From: Redd, Jason P. <JPREDD@southernco.com>
Sent: Monday, July 18, 2016 12:57 PM
To: Patel, Chandu
Subject: [External_Sender] SNC responses to Staff clarification questions re: LAR-16-009R1
Attachments: Responses to NRC Comments on LAR-90 R1 20160715 FINAL.pdf

Responses to NRC Comments on Revised Request for License Amendment Regarding Structural Design of Auxiliary Building Floors (LAR-16-009R1)

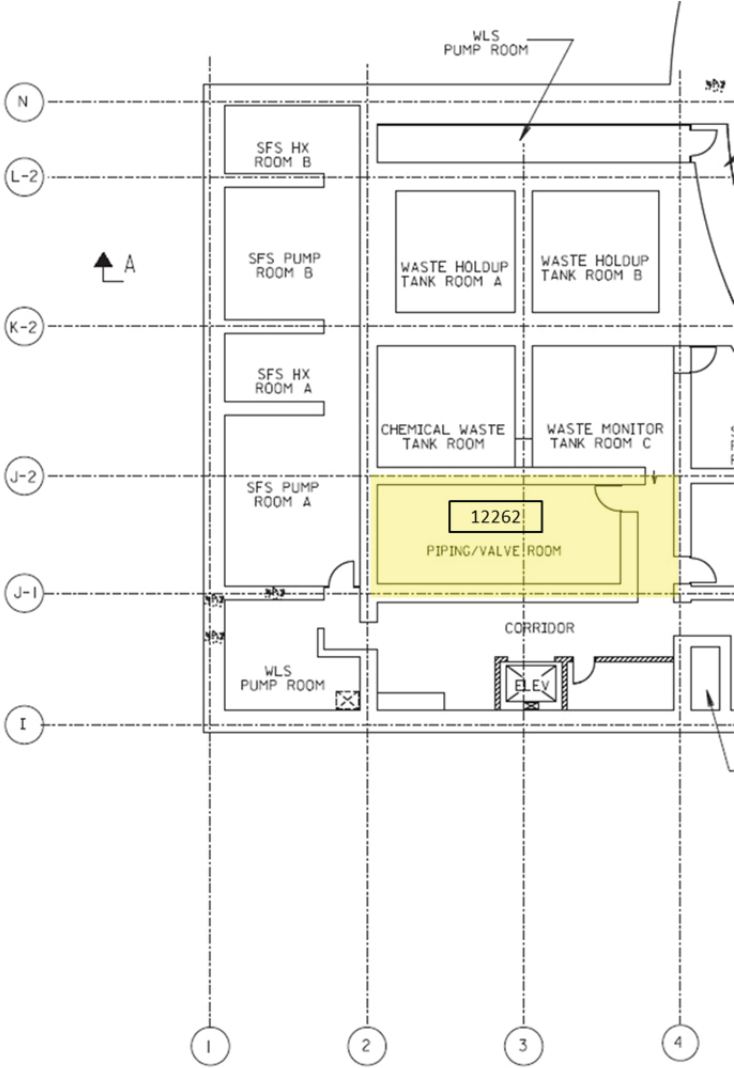
Define in text and in a reviewer's aid graphic to clarify the scope of License Amendment Request (LAR) 16-009R1, such as top of concrete (or liner) elevation for each room number, location by referencing bounding wall lines (grid), and clarify that the hallway North of room number 12262 is part of the LAR. The reviewer's aid graphic is for reference only and won't be part of UFSAR markups.

Response to NRC Comment #1:

Note that these floors are identified on page 3 of 17 of LAR-16-009R1 Enclosure 3, and are shown in UFSAR Figures 1.2-5, 1.2-6, and 3.7.2-12 (Sheets 2, 3, 10, and 11 of 12) as identified below.
